Re: Z-15-005 - Laurel Hill Valley Citizen's Association 1st Open Record Submittal

This letter and the attachments comprise the evidence submitted during the first open record period relating to the Zone Change application for the Laurel Ridge property. LHVC previously submitted written comments regarding this matter on August 14, 2015, and some additional information at the hearing on August 26th.

LHVC Sheet 9/2/15-04

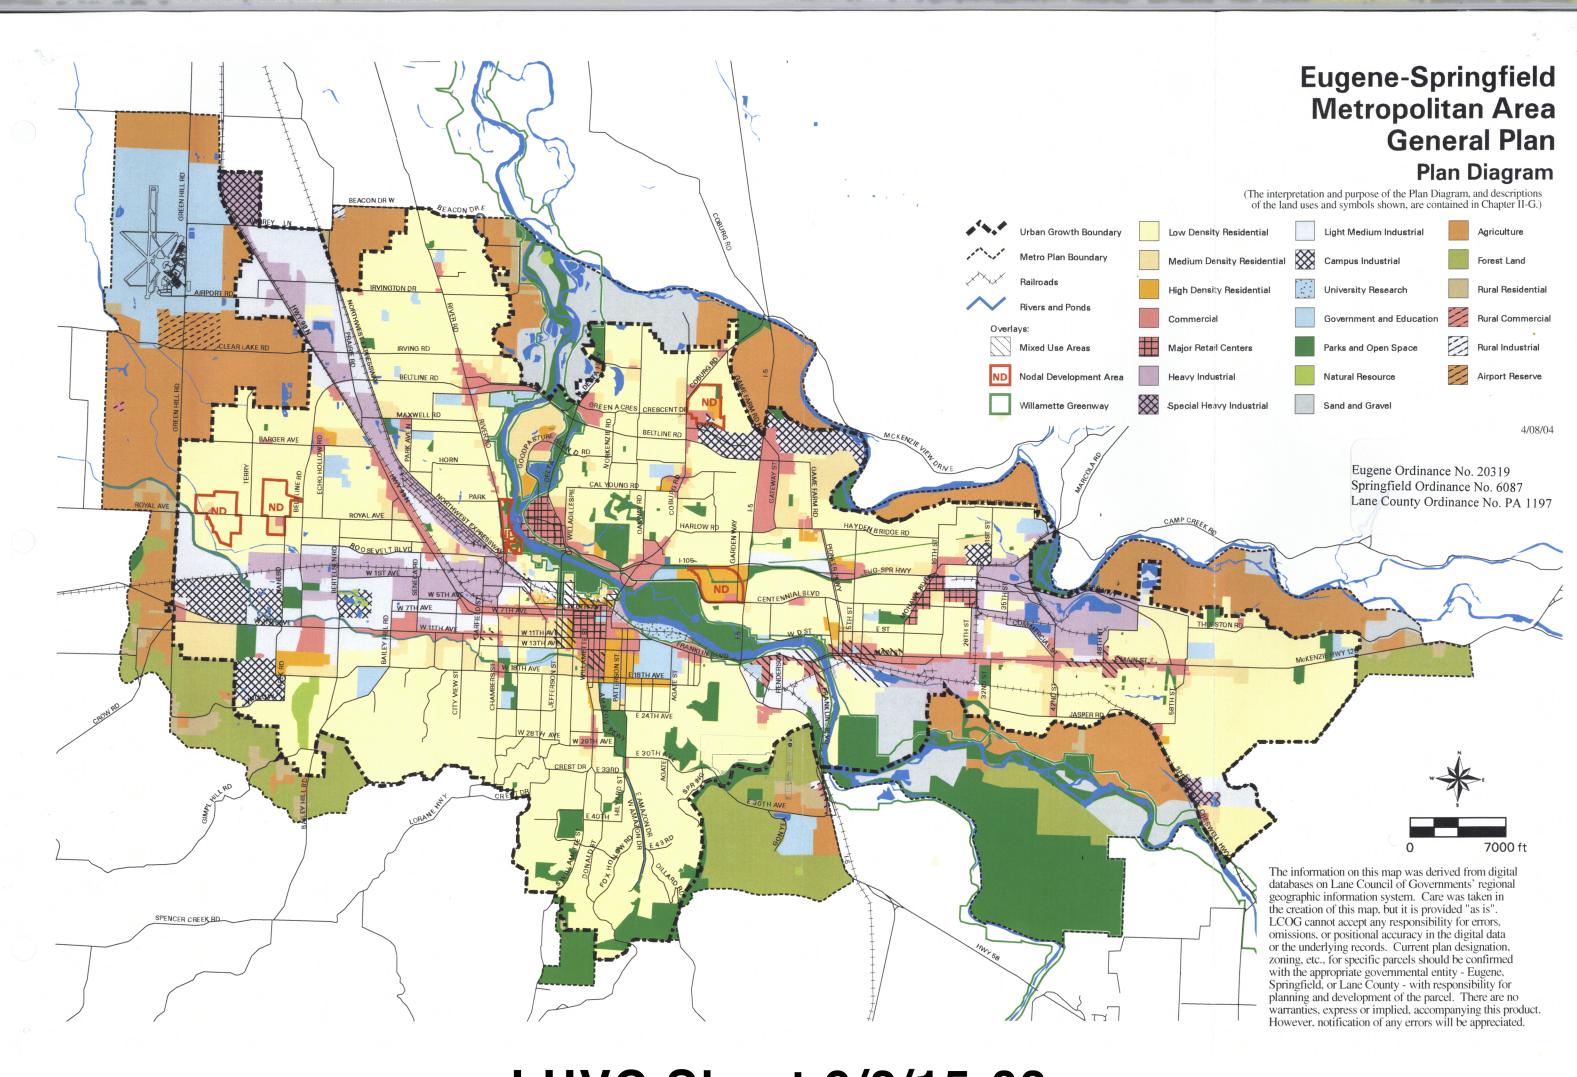
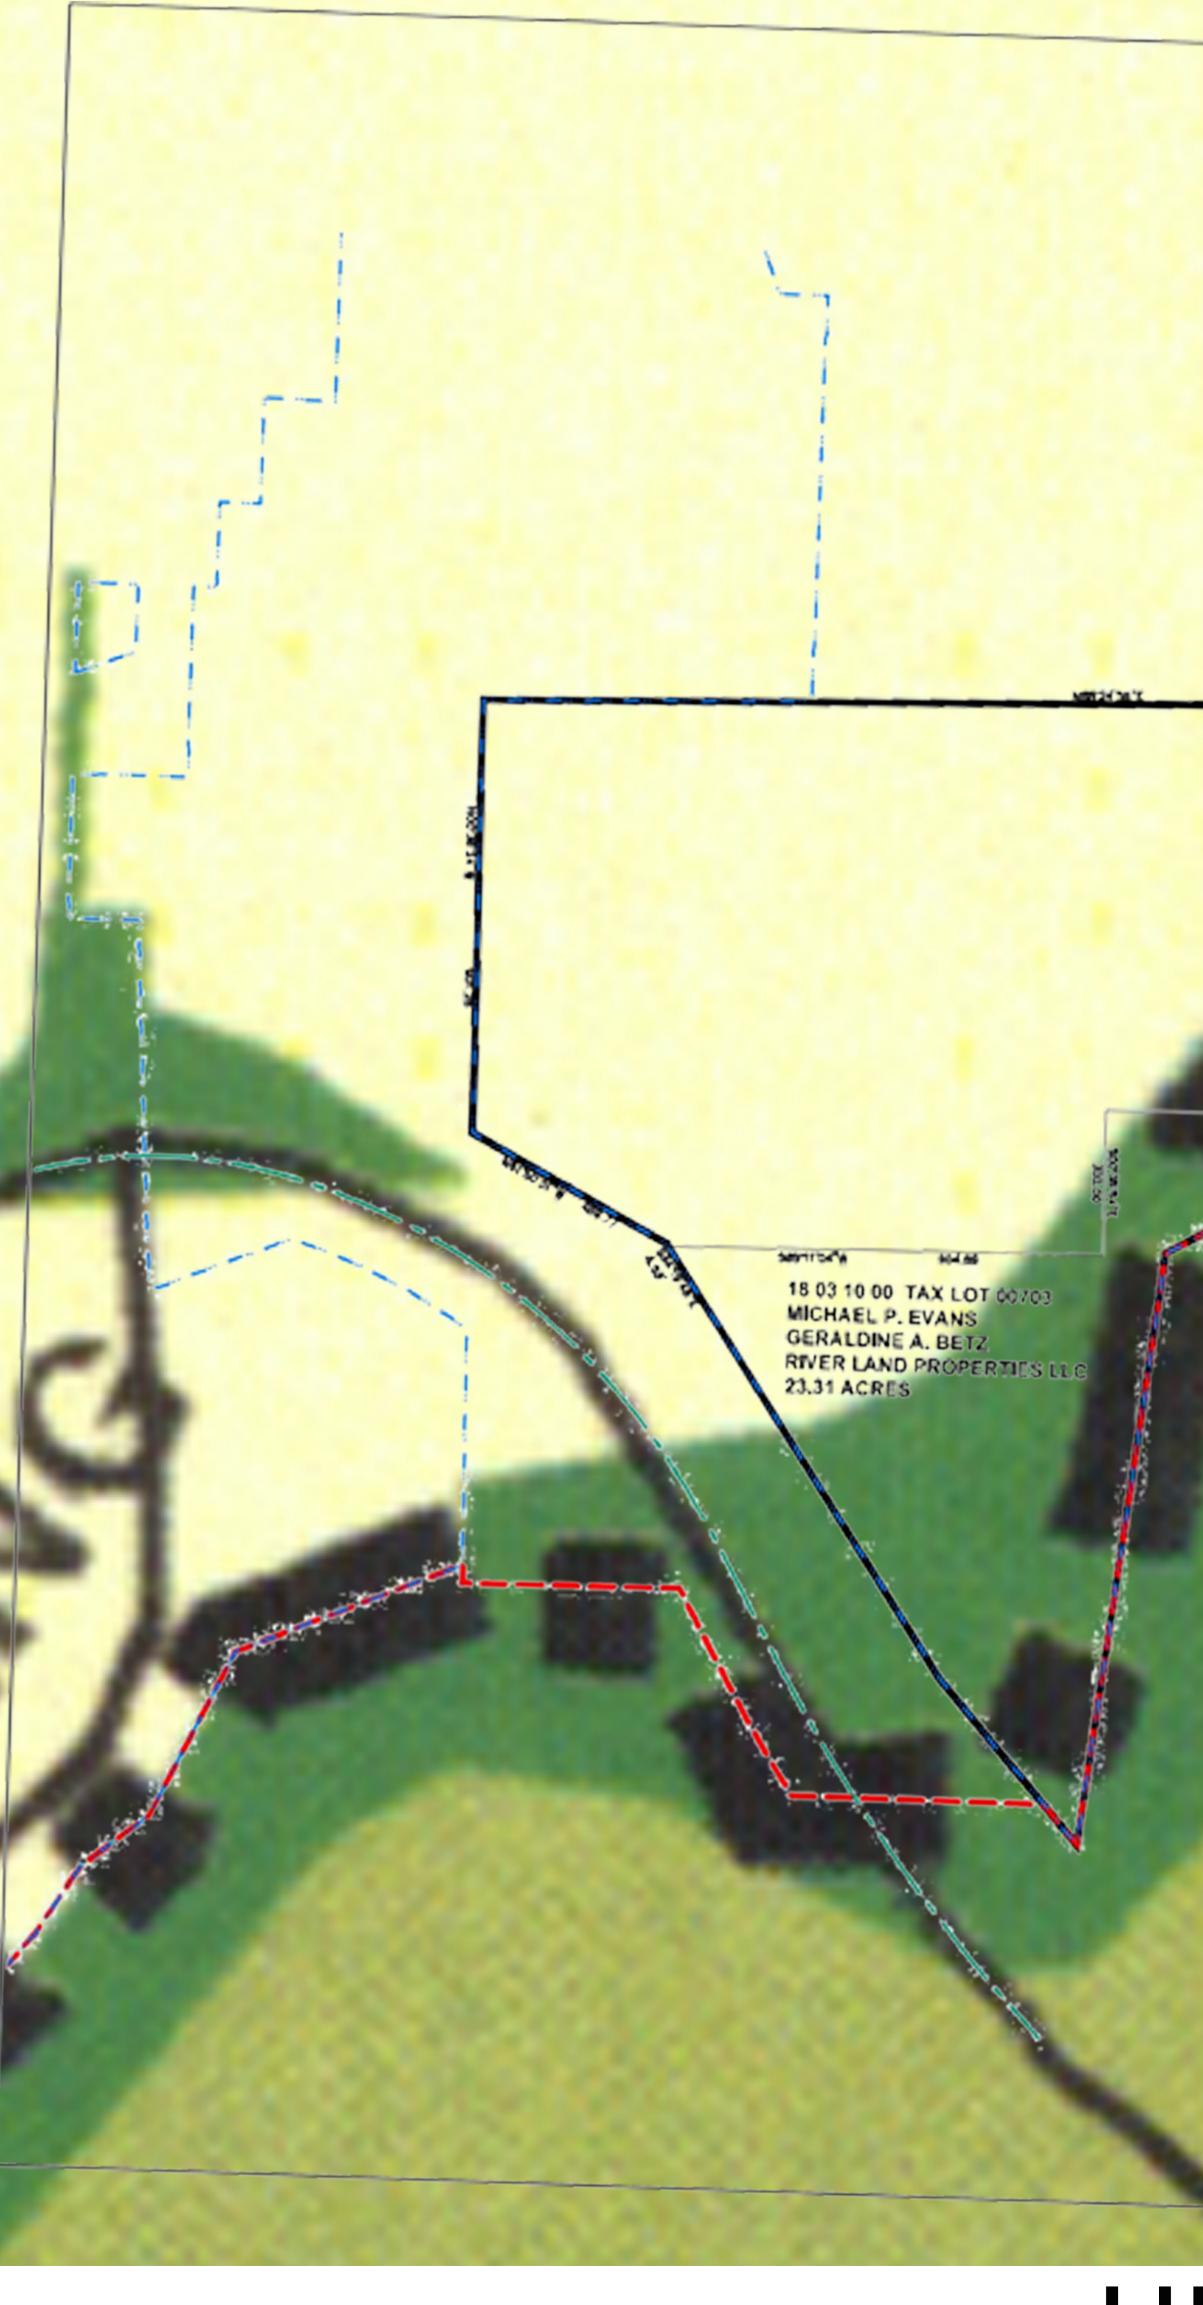
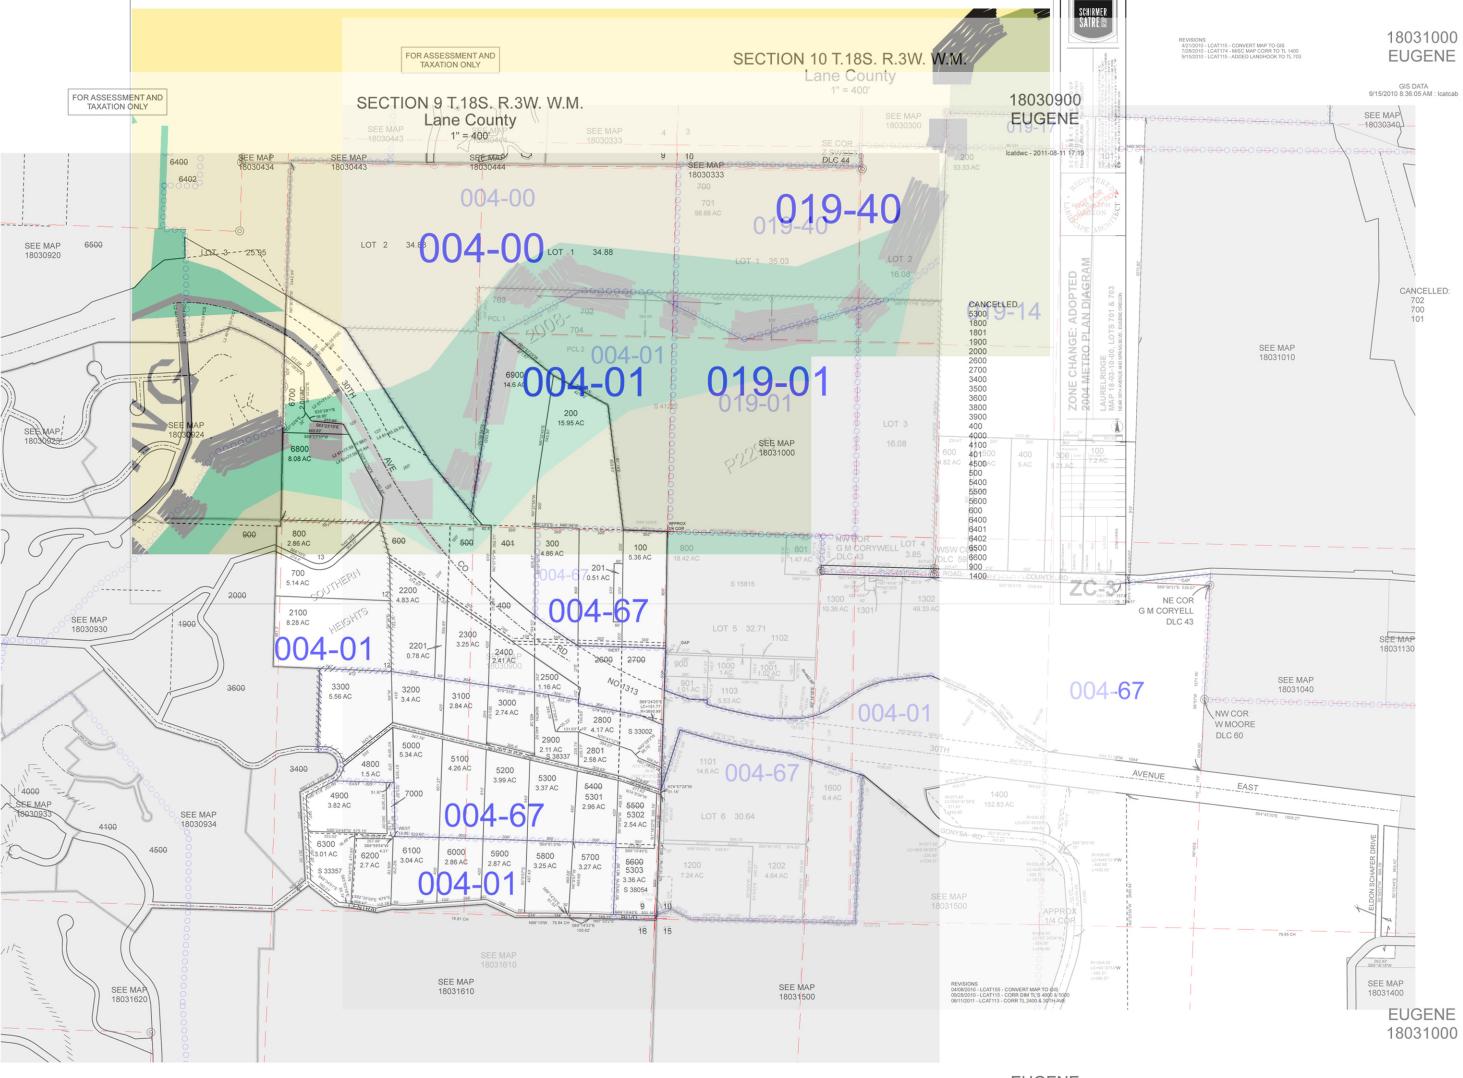
LHVC Sheet 9/2/15-04

This map is a cropped enlargement of the section of the Metro Plan Diagram with the Applicant's Sheet ZC-2 overlaid which was presented as LHVC 9/2/15/-03. Its similarity with all the other sheets and Applicant's Sheet SA7.0 is again obvious. Moreover, it should be pointed out that the enlargement results in some fuzziness of the Metro Plan Diagram, which, for some reason is not present on the Applicant's maps (Sheets ZC-3 and ZC-4).
